PROJECT: Centennial Addition and Remodel **PROJECT NO.** L13030
BID PACKAGE #2
ADDENDUM NO. 1 **DATE:** 5 AUG 2013

**CENTENNIAL
 ADDITION AND
 RENOVATION**

**BP2
 DEMOLITION
 SHEET**

C1.3R

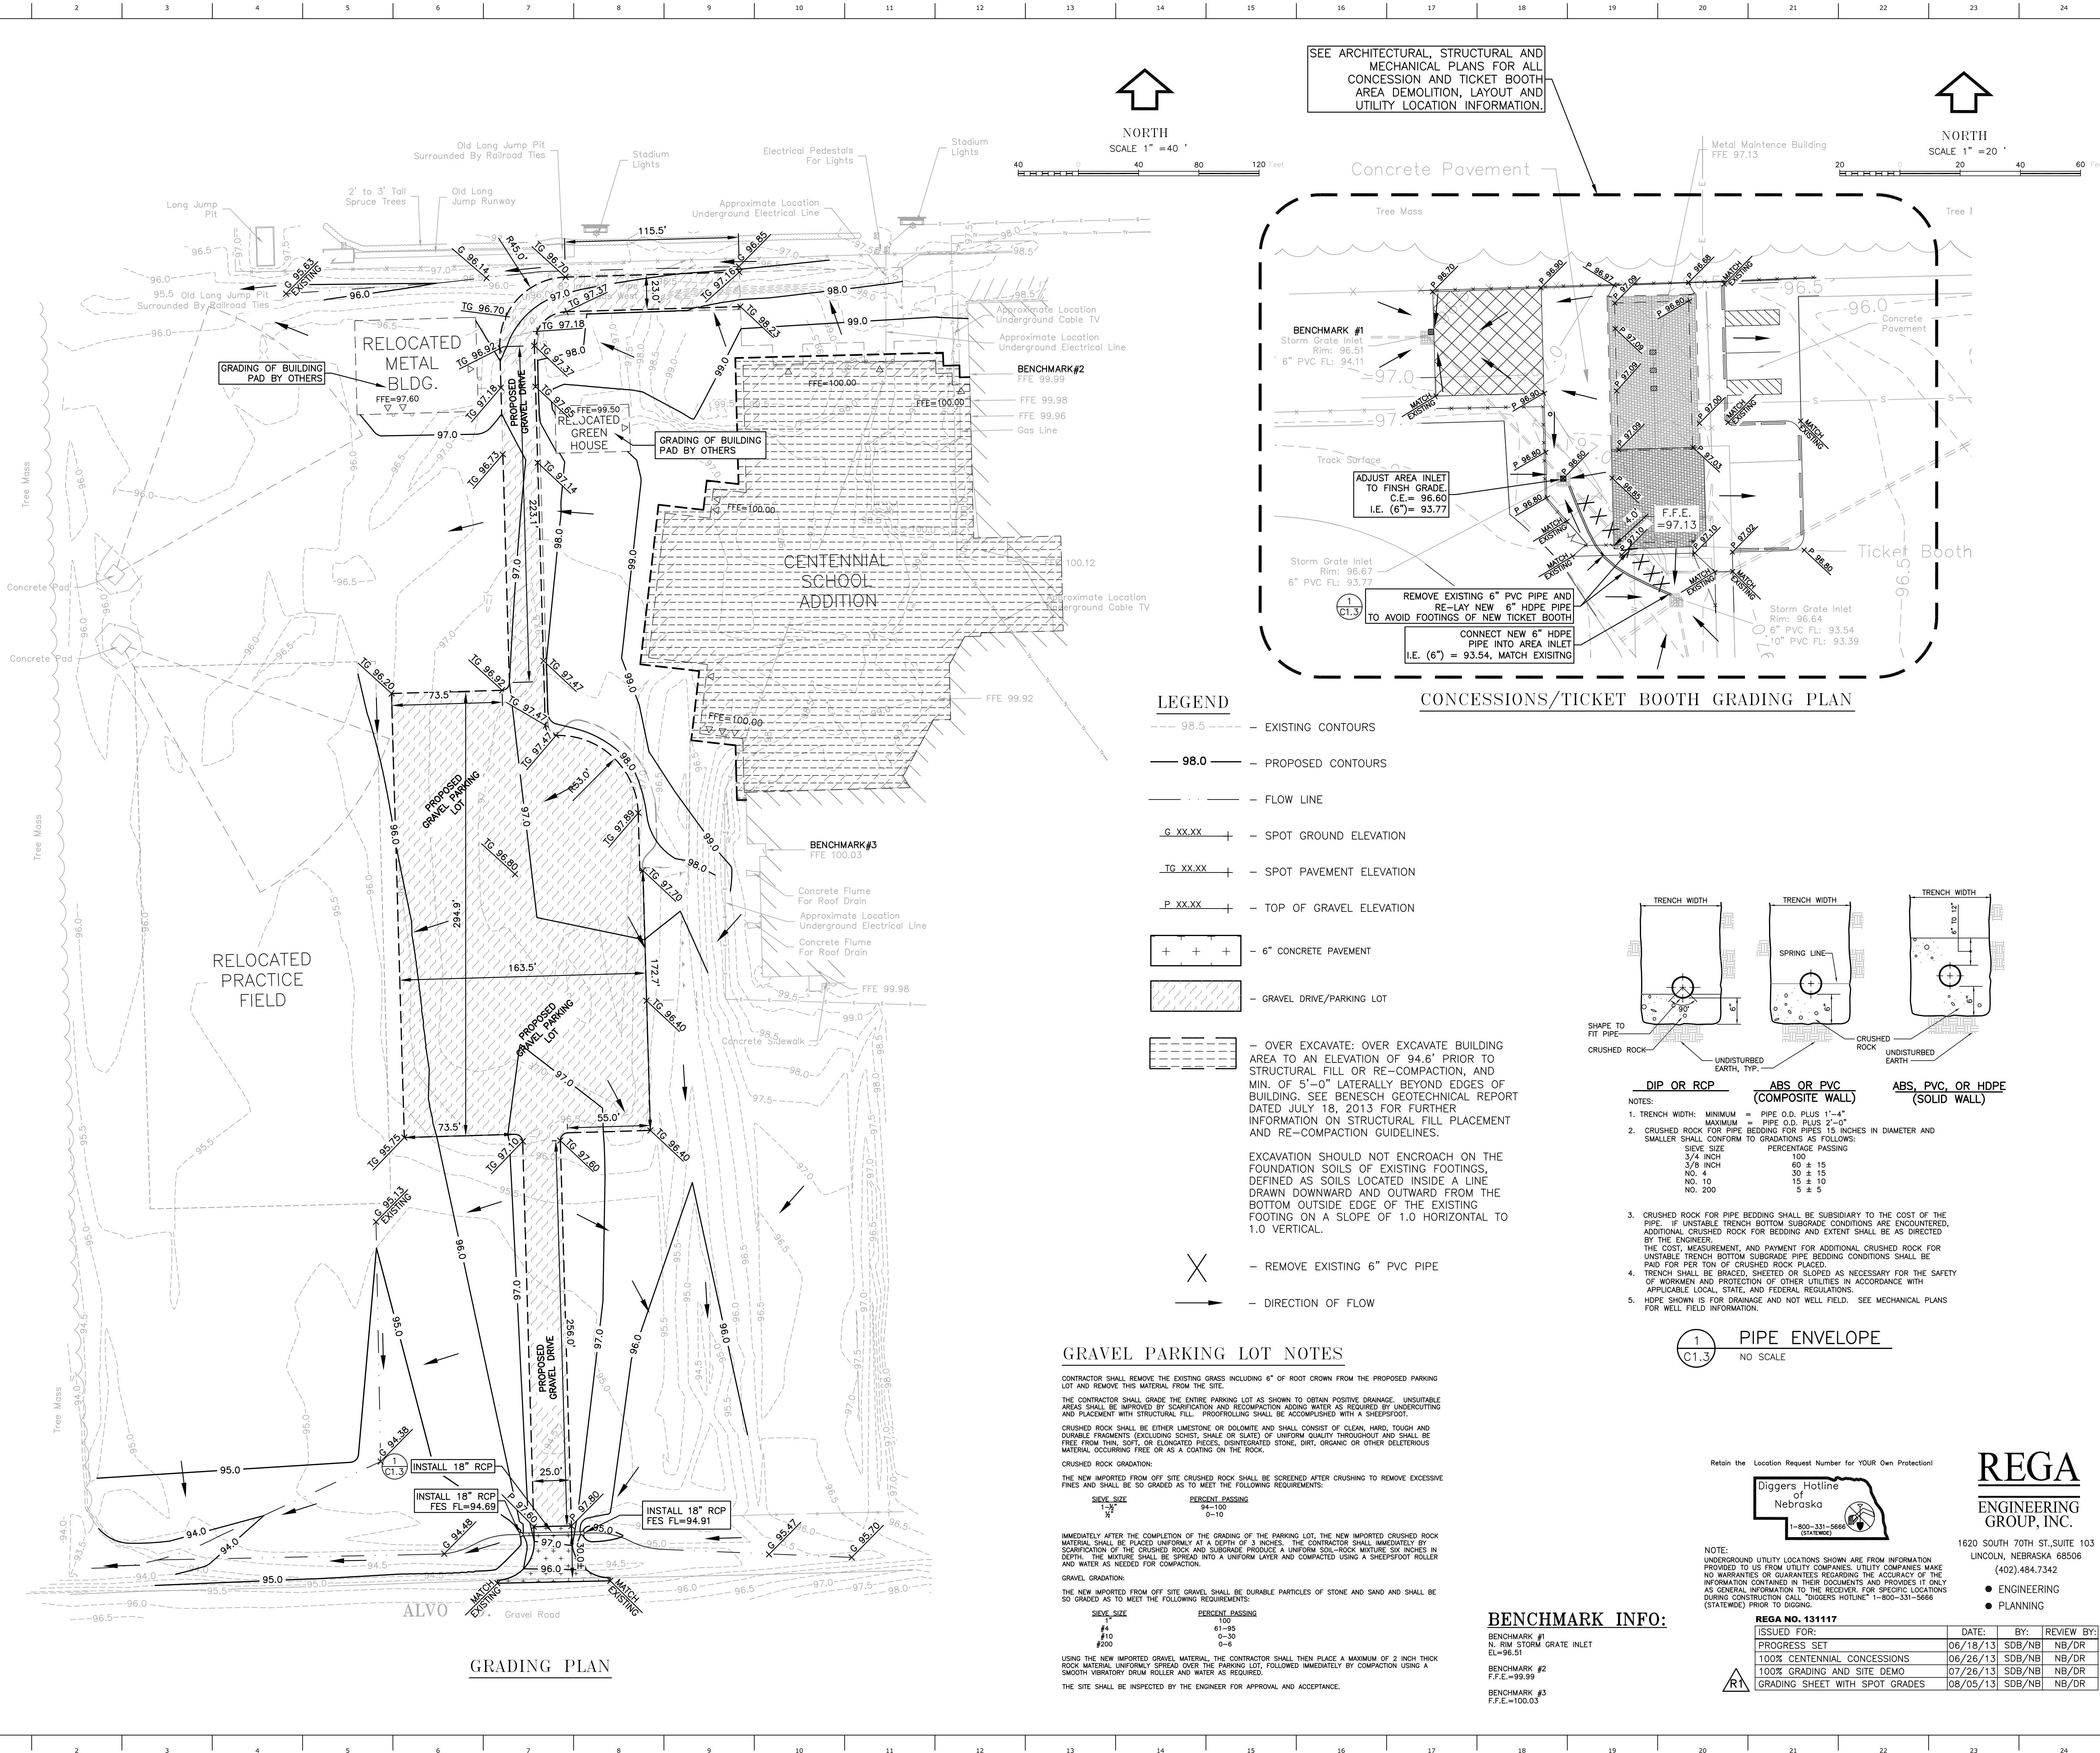
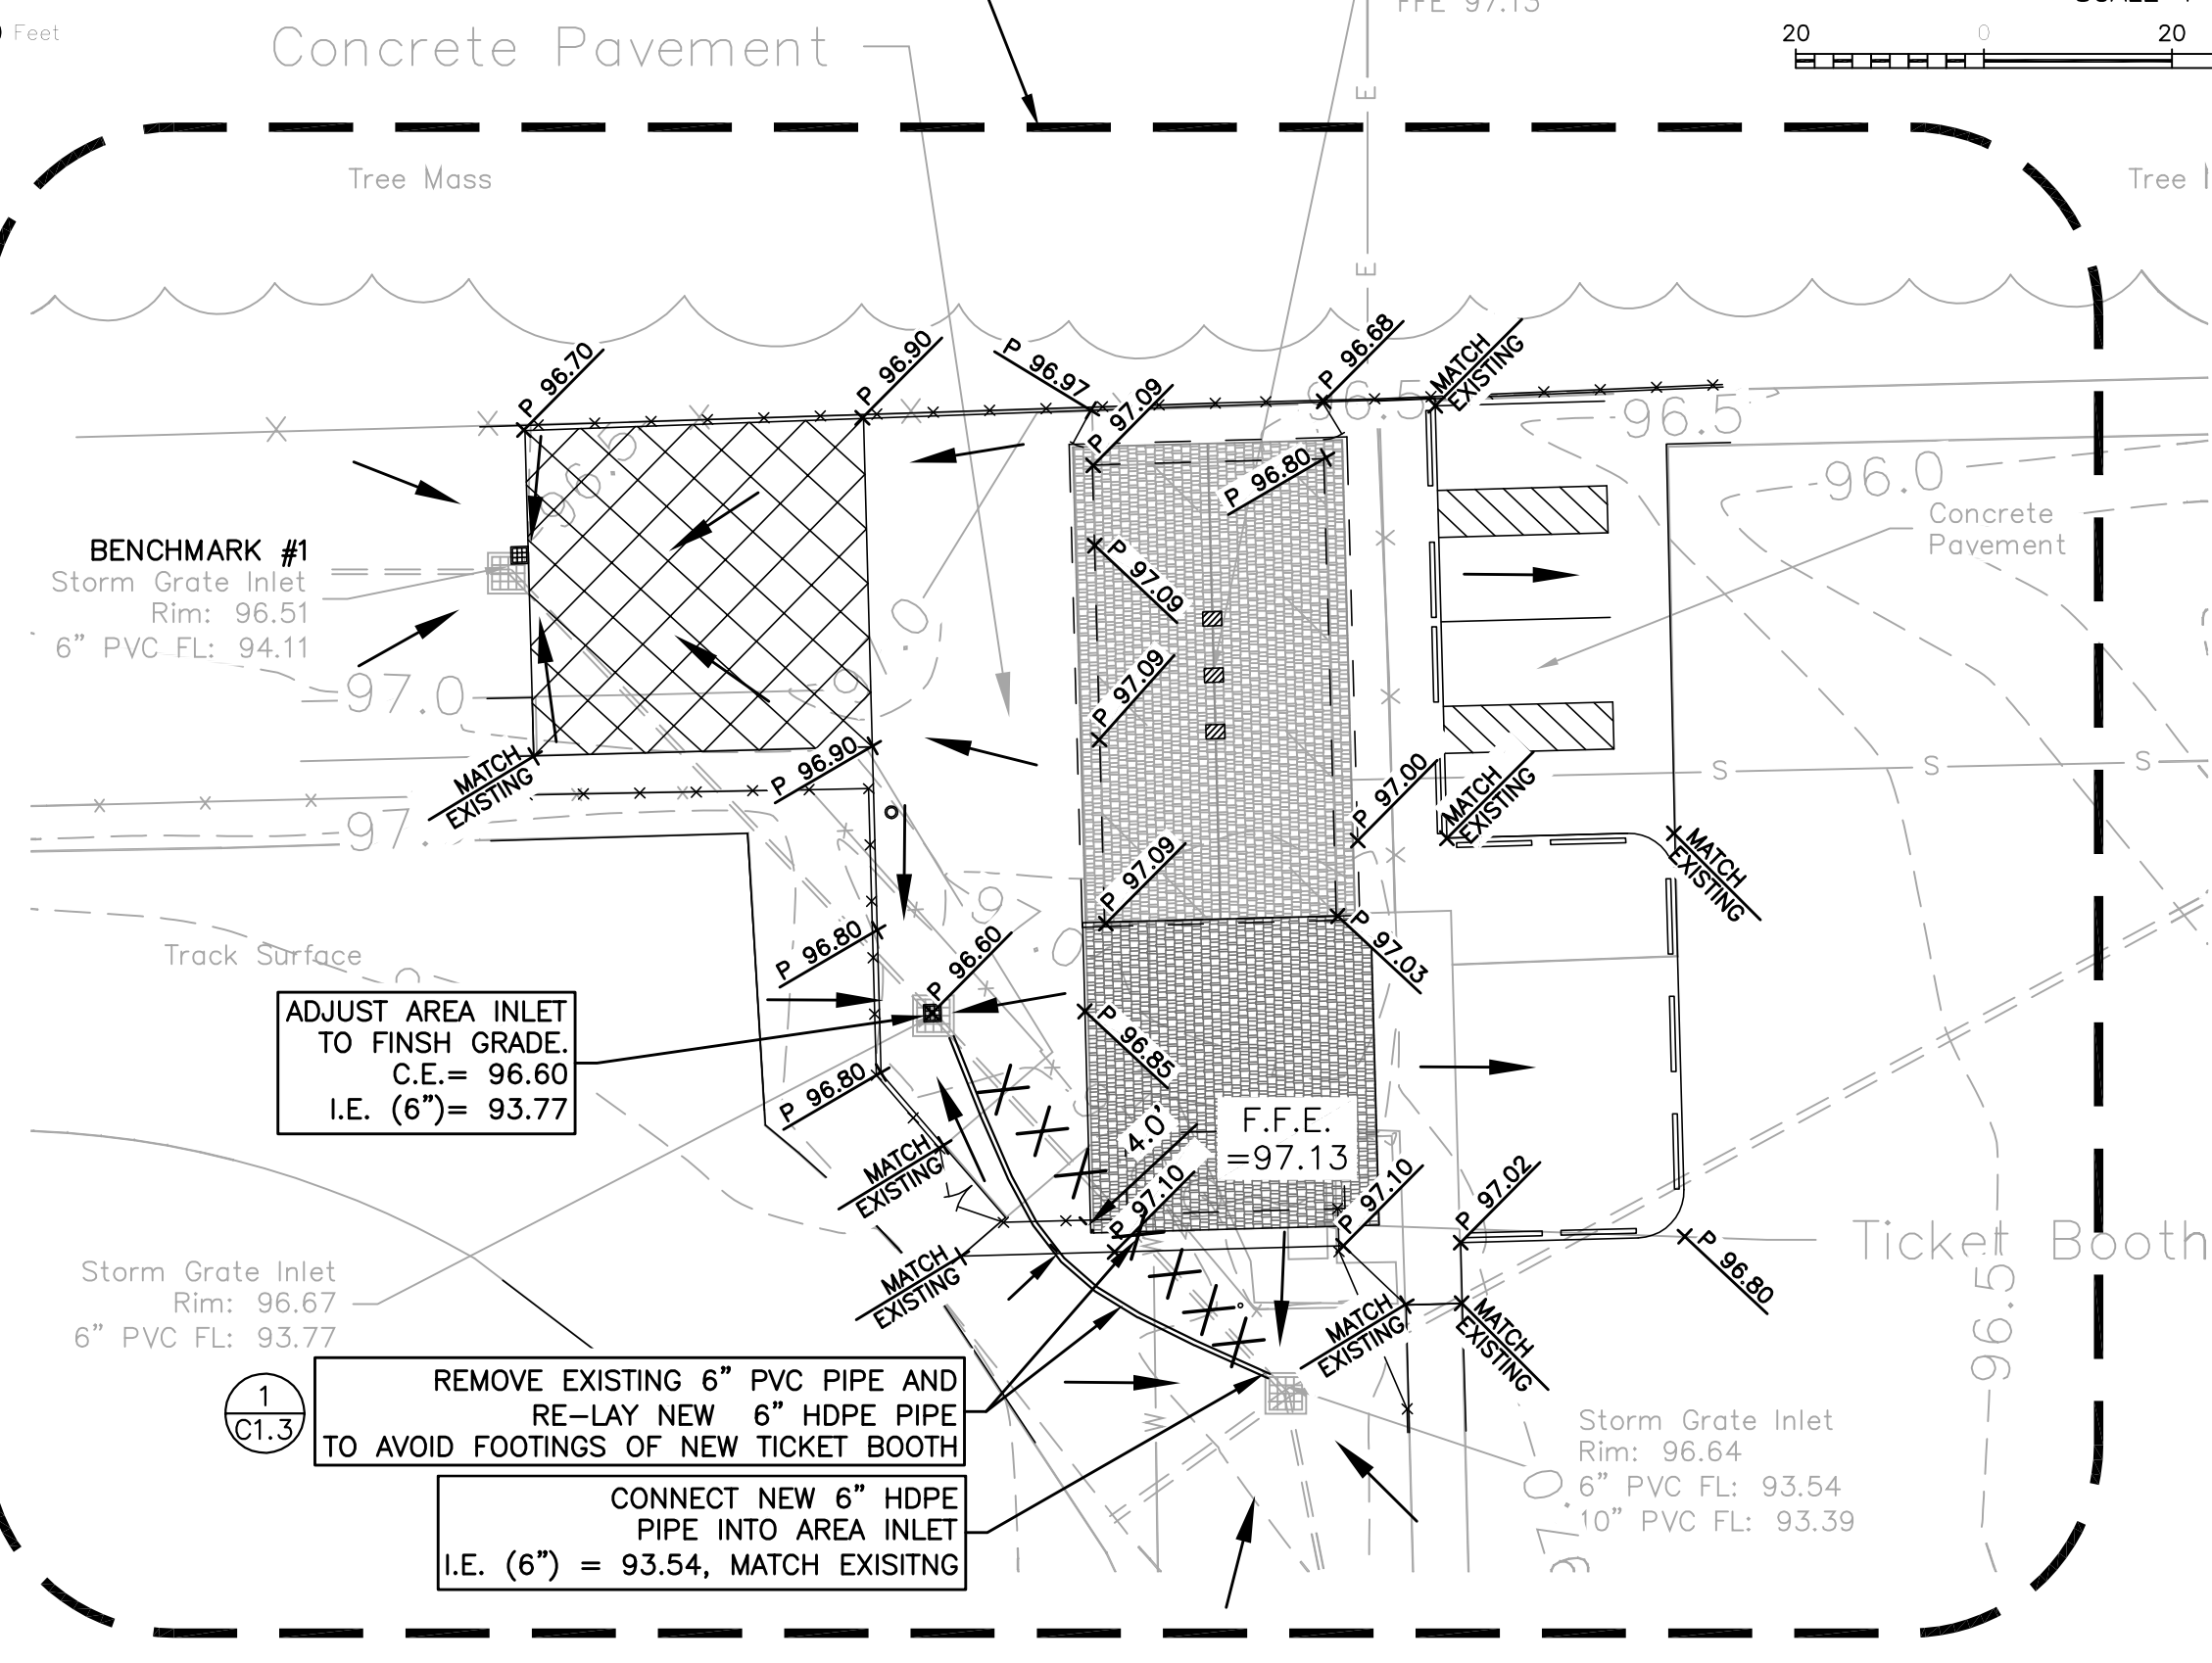
6. **GENERAL CLARIFICATION**
It was the CM's intent to have the rock drive and lot be included in the Site Demo and Grading Package. The originally issued drawings did not give any design parameters for final drive

locations, parking lot dimensions, design on fabric, rock gradation etc. See below and enclosed for revised drawings showing this work to be included in the scope of work.

1. For building demolition see Sheet D1.1 included herein.
 - A. "[Click here & type Detail #]"
2. The attached Civil drawings shall revise or replace previously issues drawings;
 - B. Reference Sheet C1.1 with revisions to sheet C1.1.
 - C. Sheet C1.3R – Grading Overview Plan, replacement for sheet C1.3.

CONTRACTOR SHALL REMOVE THE EXISTING GRASS INCLUDING 6" OF ROOT CROWN FROM THE PROPOSED PARKING LOT AND REMOVE THIS MATERIAL FROM THE SITE.

THE CONTRACTOR SHALL GRADE THE ENTIRE PARKING LOT AS SHOWN TO OBTAIN POSITIVE DRAINAGE. UNSUITABLE AREAS SHALL BE IMPROVED BY SCARIFICATION AND RECOMPACTION ADDING WATER AS REQUIRED BY UNDERCUTTING AND PLACEMENT WITH STRUCTURAL FILL. PROOFROLLING SHALL BE ACCOMPLISHED WITH A SHEEPSFOOT.

IMMEDIATELY AFTER THE COMPLETION OF THE GRADING OF THE PARKING LOT, THE NEW IMPORTED CRUSHED ROCK MATERIAL SHALL BE PLACED UNIFORMLY AT A DEPTH OF 3 INCHES. THE CONTRACTOR SHALL IMMEDIATELY BY SCARIFICATION OF THE CRUSHED ROCK AND SUBGRADE PRODUCE A UNIFORM SOIL-ROCK MIXTURE SIX INCHES IN DEPTH. THE MIXTURE SHALL BE SPREAD INTO A UNIFORM LAYER AND COMPACTED USING A SHEEPSFOOT ROLLER AND WATER AS NEEDED FOR COMPACTION.

USING THE NEW IMPORTED GRAVEL MATERIAL, THE CONTRACTOR SHALL THEN PLACE A MAXIMUM OF 2 INCH THICK ROCK MATERIAL UNIFORMLY SPREAD OVER THE PARKING LOT, FOLLOWED IMMEDIATELY BY COMPACTION USING A SMOOTH VIBRATORY DRUM ROLLER AND WATER AS REQUIRED.
